AW-40-12 - 25 Kingsway - OBJECTION 18-3-2012

OBJECTION to AW/40/12 - 25 Kingsway - Alteration to front elevation

'B'

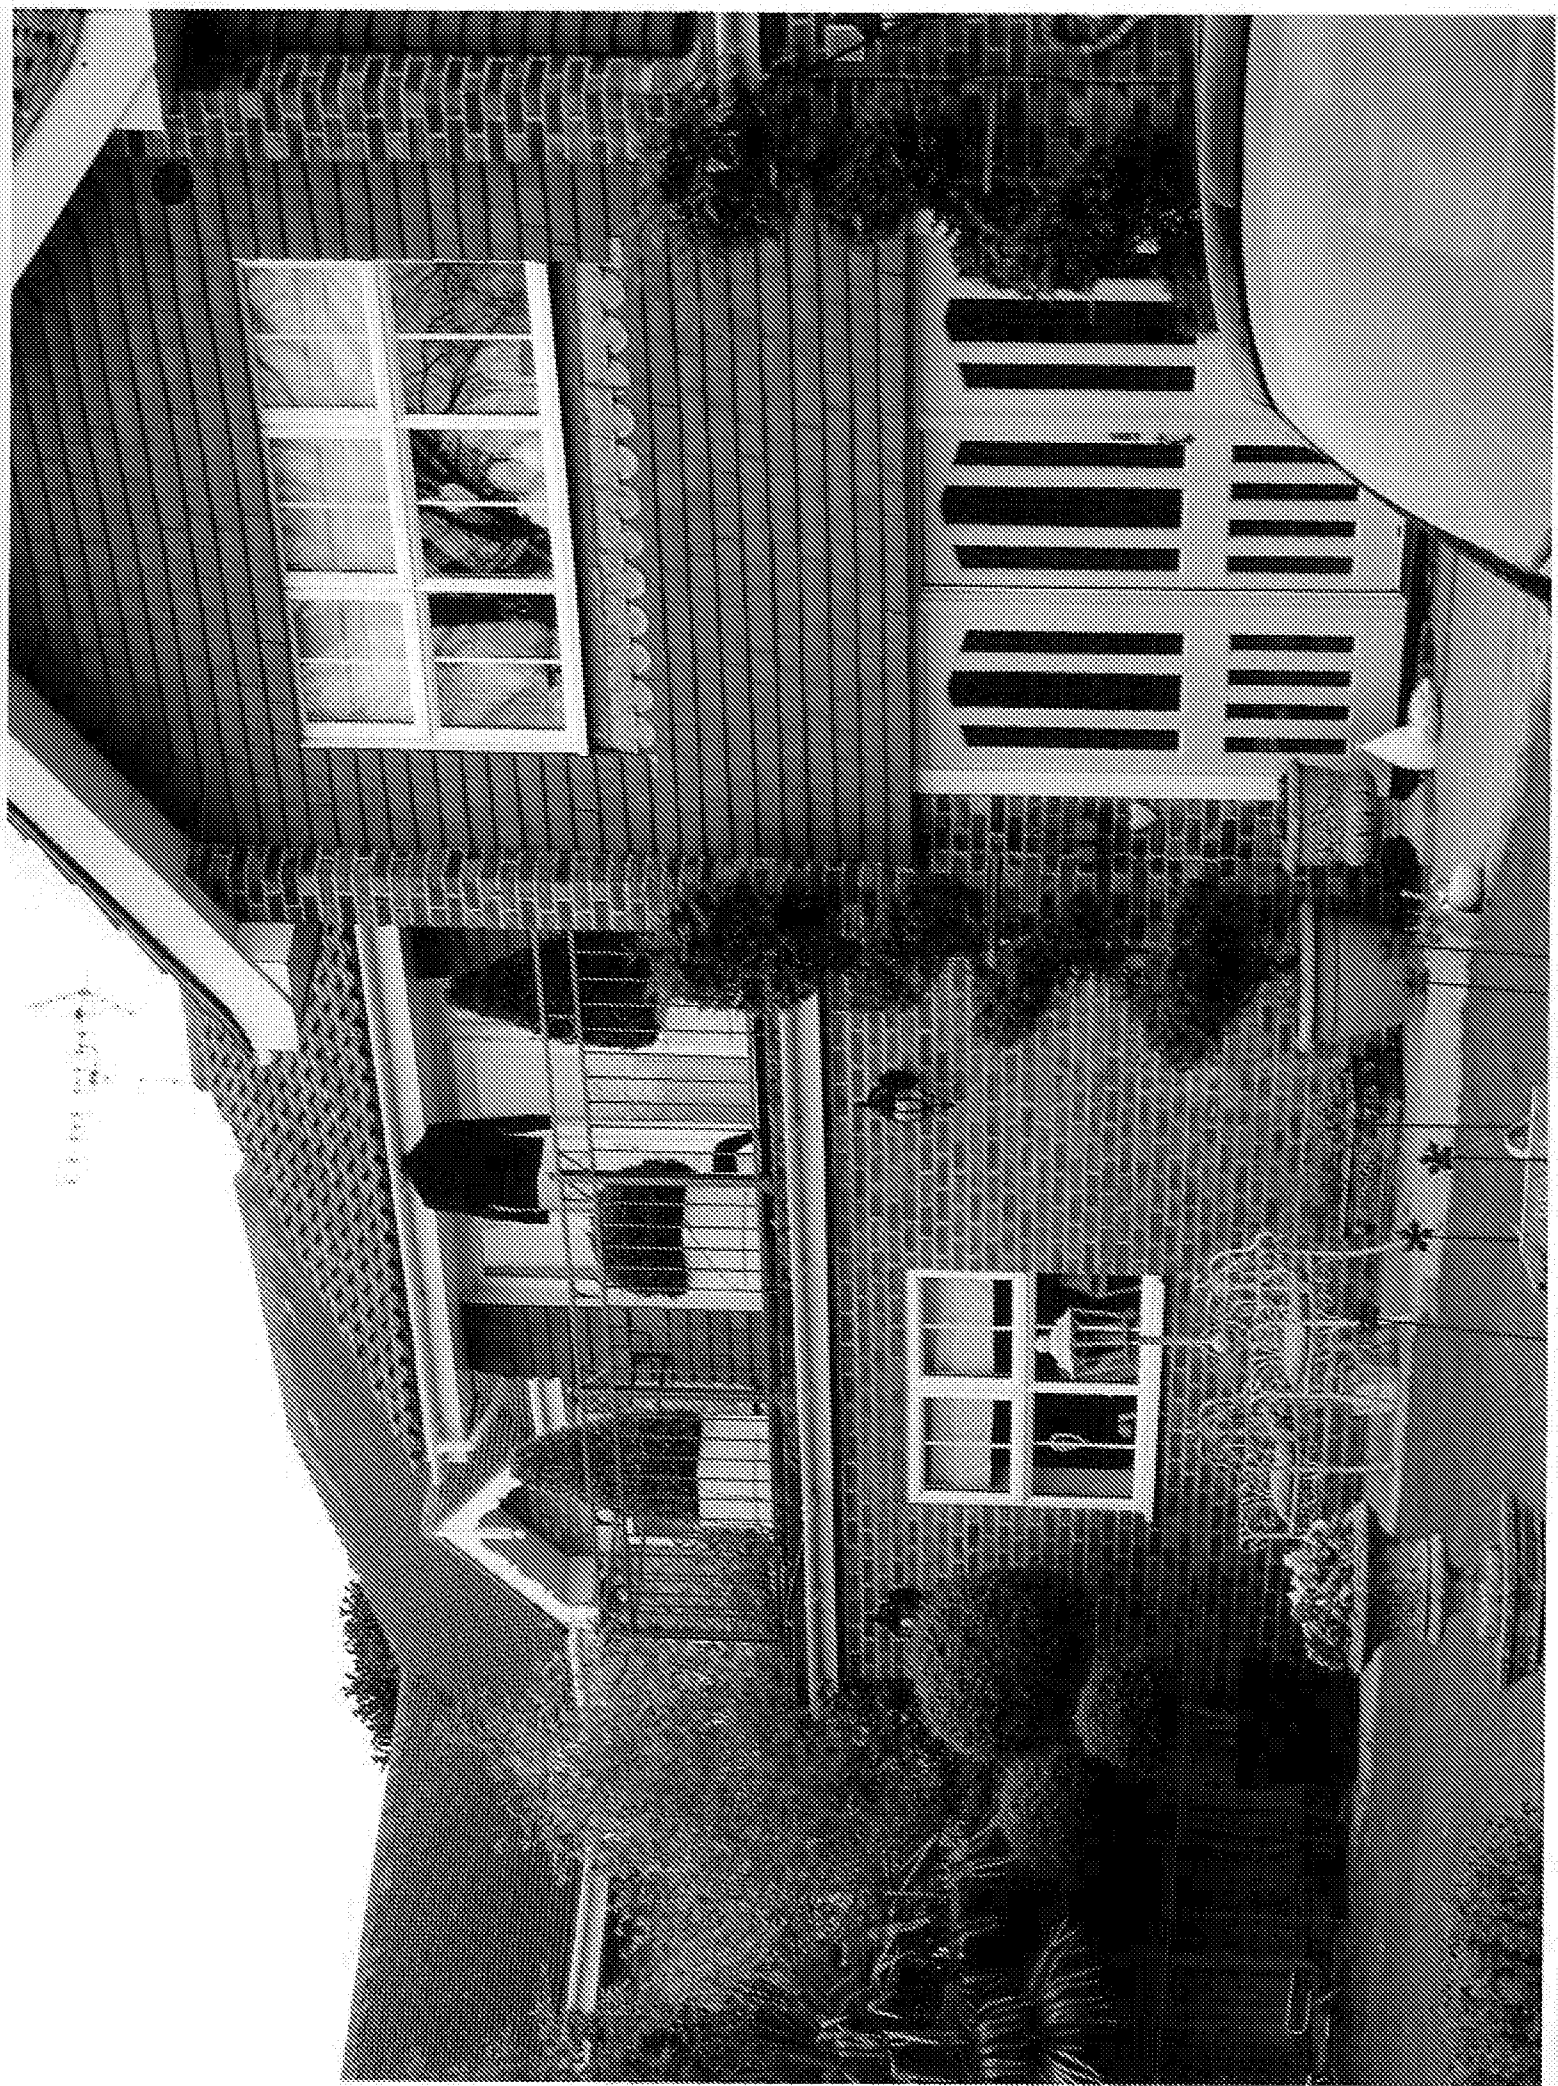
2. CHECAA does not accept that the proposed lean-to tile covering of the garage is a 'catslide' roof, as is claimed, and the term is wrongly used, in our view. Such a low pitched tiled roof would destroy the existing symmetry (see photographs 'A', 'B' and 'C') in exactly the same way as would the applicant's proposals in AW/119/09 which was refused and objected to by CAAC who commented adversely upon those garage alterations which they said 'strong objection to the garage which subtracts from the symmetrical appearance of the property'. Current proposals would also do that and have an adverse impact upon the house and CHCA. Sir Edwin Lutyens was a pioneer of 'catslide' roofs and a photograph ('D') of one is attached for comparison. Counting the hung tiles from the garage roof to the window shows that the roof will rise from nil at the front (south) gutter by no more than 300mm at the window cill. The street scene will be merely 3-4 rows of grey tiles against the red wall hung tiles and we see no merit in that.

'E'

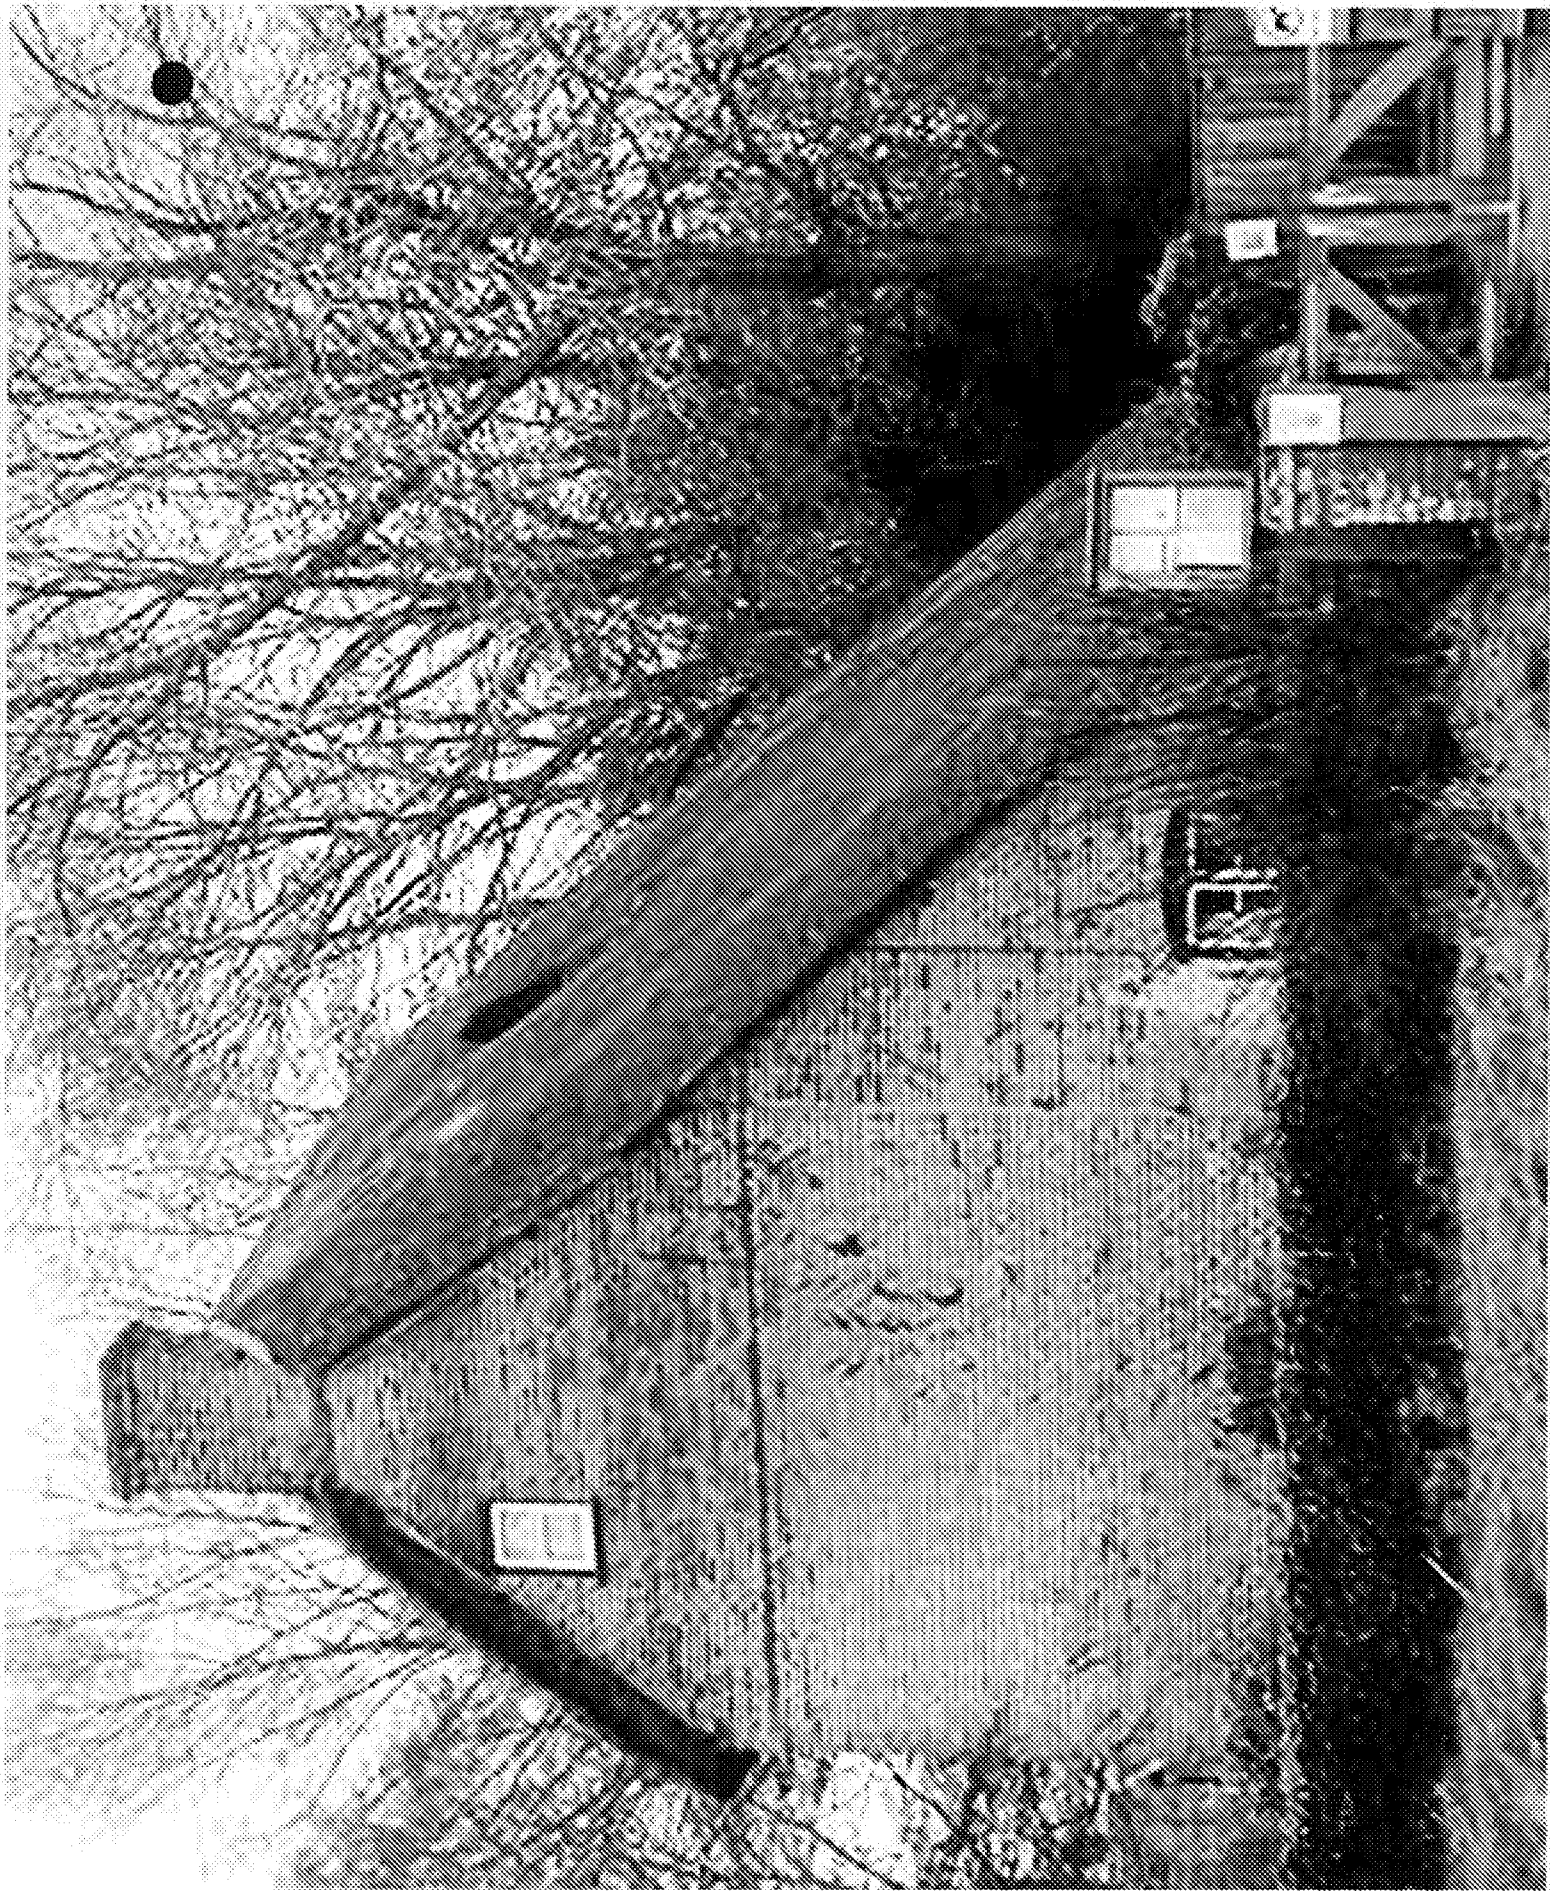
The houses around 25 Kingsway are circa 1970/80's and sit comfortably and unobtrusively together as a reasonable example of that period. They are certainly not 'of no particular architectural merit' as the applicant states in his Design and Access Statement (D&AS), but CHECAA firmly considers it fair and appropriate to say that it considers the current development proposals to be of no merit whatever. They do not serve to make a *positive contribution* nor to *enhance* nor *preserve* the environment or the established character of Craigweil House Conservation Area. See photo's 'E' and 'F'.
